Response to Submissions

South East Open Cut Project
&
Modification to the
Existing ACP Consent

Ashton Coal Operations Pty Limited

Wells Environmental Services

Figure 1
 South East Open Cut Project
 Exploration hole water strike
 information

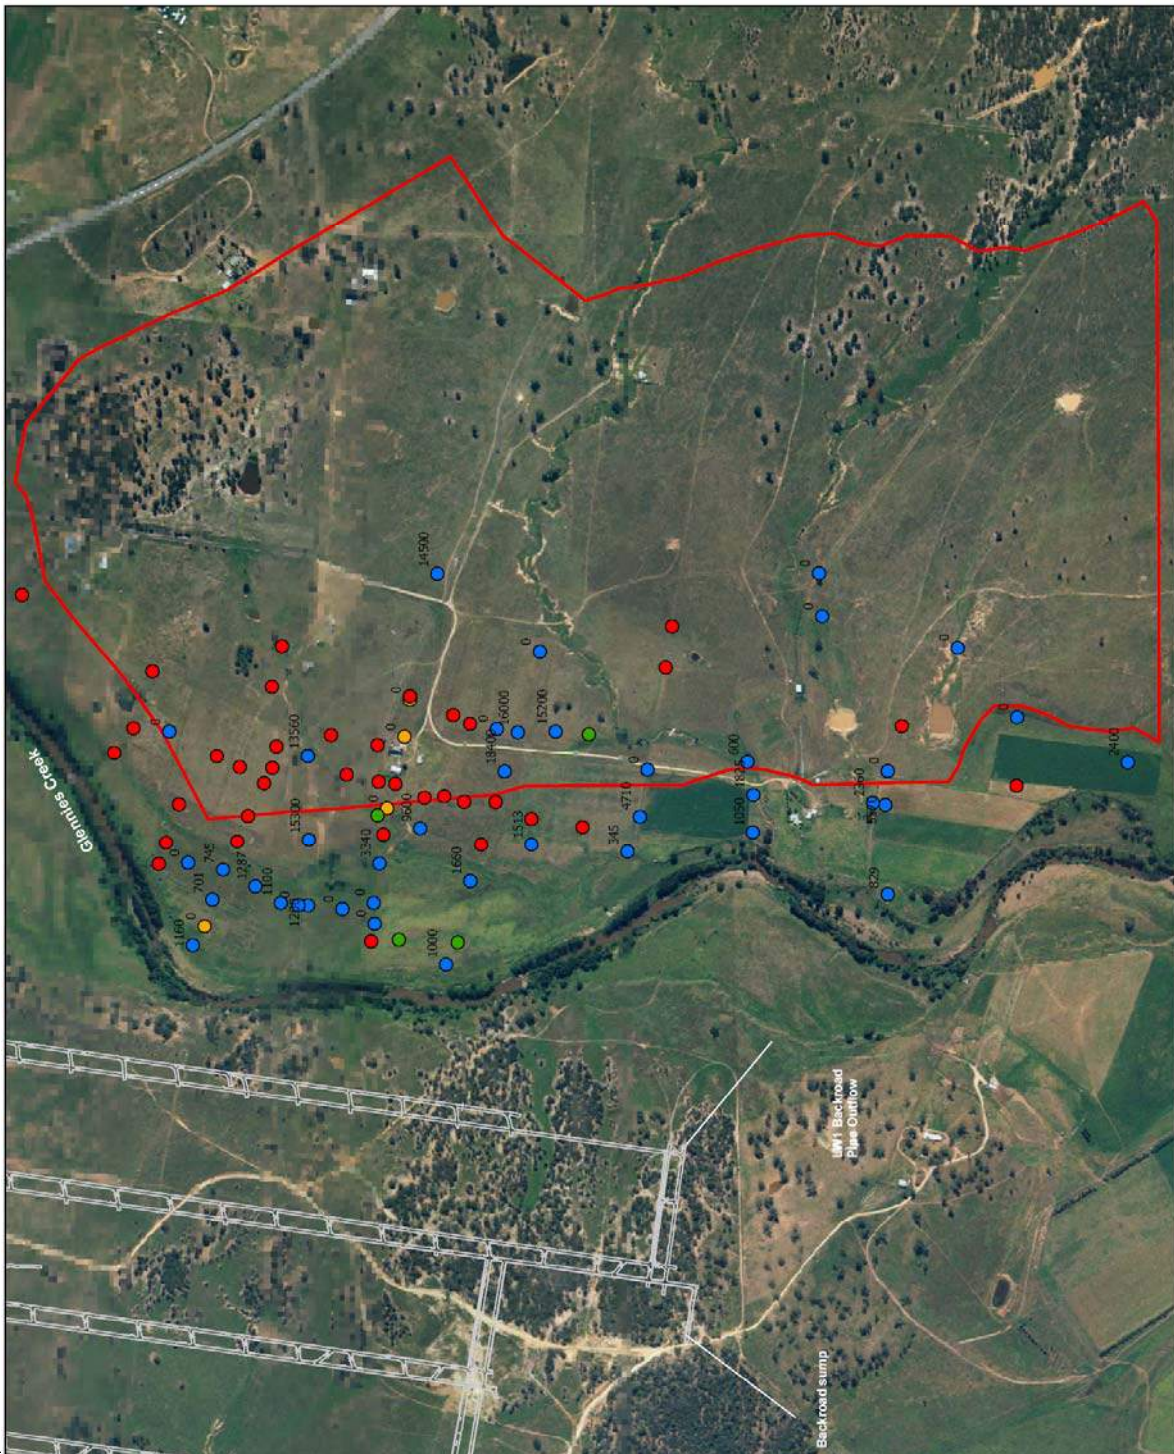
- ▼ **Para 1:** The use of the phrase 'highly connected' is somewhat misleading in this paragraph. Whilst some parts of the alluvium are 'highly connected', Aquaterra carried out a number of pump tests that involved boreholes that penetrated the entire thickness of the saturated alluvium. Many of these bores showed low permeability, particularly in the northern half of the pit shell. An overview of the permeabilities encountered is provided in *Figure 4.7 of the Groundwater Impact Assessment Report* shows the values that were used. A copy of **Figure 4.7** is presented, for reference in **Appendix A** of this memo. In addition to these tested permeabilities, many of the boreholes that were not hydraulically tested were dry when drilled, or did not contain enough water to provide a groundwater sample. These were fully completed through the alluvium/colluvium and show very low permeability. An overview of the location of the dry and 'moist' boreholes that were drilled is shown in **Figure 1**. This shows extensive dry areas along the western pit boundary, which further supports the general conclusions over permeability contained in *Figure 4.7 of the Groundwater Impact Assessment Report*. Based on the results of the investigations, it would be far more appropriate to describe the alluvium as '... a complex system of interacting/directly-connected alluvial layers/lenses, and non-interacting/poorly-connected alluvial layers, which become more dominant towards the pit shell'

It is not clear what the relevance of the statement relating to the southern 200m of the proposed open cut pit is. *Appendix B, Transect 10 of the Groundwater Impact Assessment Report* shows that the pit boundary in this area is incised into a rapidly rising Permian basement, and there are no saturated unconsolidated materials (alluvium or colluvium) present at the pit boundary in this location.

Figure 1 above shows the much greater predominance of dry boreholes that occurred across much of the pit shell, indicating very low permeability, even in areas where transects suggested that saturated materials should be present.

Figure 2: Ongoing Monitoring Results for Glennies Creek Alluvium

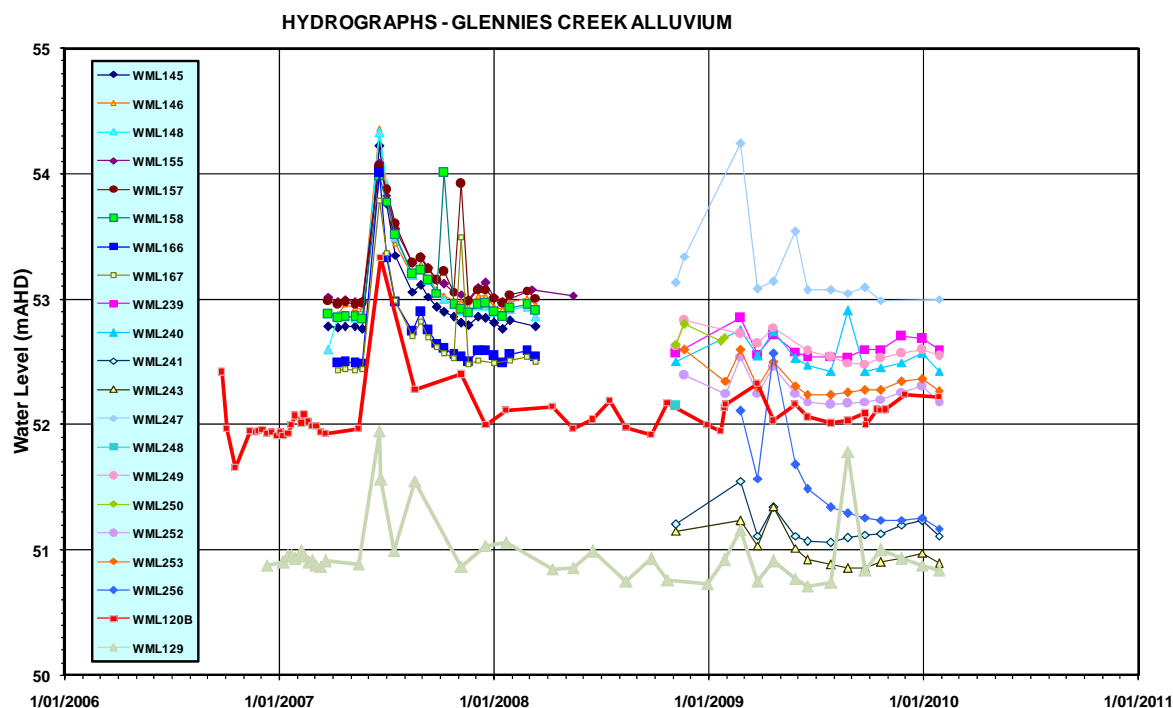
- ▼ **Para 2:** The investigations for the Groundwater Assessment Report have shown that impacts on the Glennies Creek water source will be minimal, and ACOL are proposing that the full impact is offset by the use of high security surface water licence. Although the pit shell does intersect some unconsolidated materials, the impact assessment shows that these are not well connected to the Glennies Creek alluvium. It is acknowledged that the pit shell is located within 150m of the connected alluvium, but extensive testing and risk analysis (which is further evaluated below) has shown that the inflows from the water source to the pit will be small and can be mitigated through licence offset. It is therefore considered that the project is in compliance with the Stream/Aquifer Guidelines. Although the pit shell is located within 150m of the connected alluvium of a Schedule 3 stream, the investigations have been carried out to a point whereby the geology and potential interaction between the pit shell and the alluvium is understood well enough so that the potential interactions between the pit, alluvium and creek can be fully quantified, and whereby the risks and uncertainties can be fully evaluated. This memorandum contains updated risk/scenario assessments (as described in the **Groundwater Sensitivity Modelling Section** below) that show the impact of the pit on Glennies Creek cannot be large, and will be no more than 30% above the baseline scenario shown in the EA, even if extremely conservative assumptions are used.

The monitoring that is available clearly shows that rises in alluvium water levels are transient and only occur after larger rainfall events (and rarer flood events). Alluvial water levels are controlled by recharge rates from rainfall, and baseflow discharges are controlled by the difference between groundwater levels and water levels within Glennies Creek, not flow rates. Baseflow rates will tend to be insensitive to long term climatic variation. Water levels in the creek are also influenced by discharges from the Glennies Creek Dam upstream, while alluvium groundwater levels only tend to fluctuate by small amounts between rainfall or spate/flood flow events.

This is confirmed by the ongoing monitoring data that has been gathered since the impact assessment was submitted, as provided in **Figure 2**. The hydrographs show a significant recharge event following the large rainfall in June 2007, which also saw flooding in Glennies Creek and the Hunter River. However, subsequent recharge events in response to rainfall without any flooding in August 2007, December 2007, March 2008, February 2009, April 2009, and the period July-October 2009 confirm that rainfall infiltration is the primary recharge mechanism.
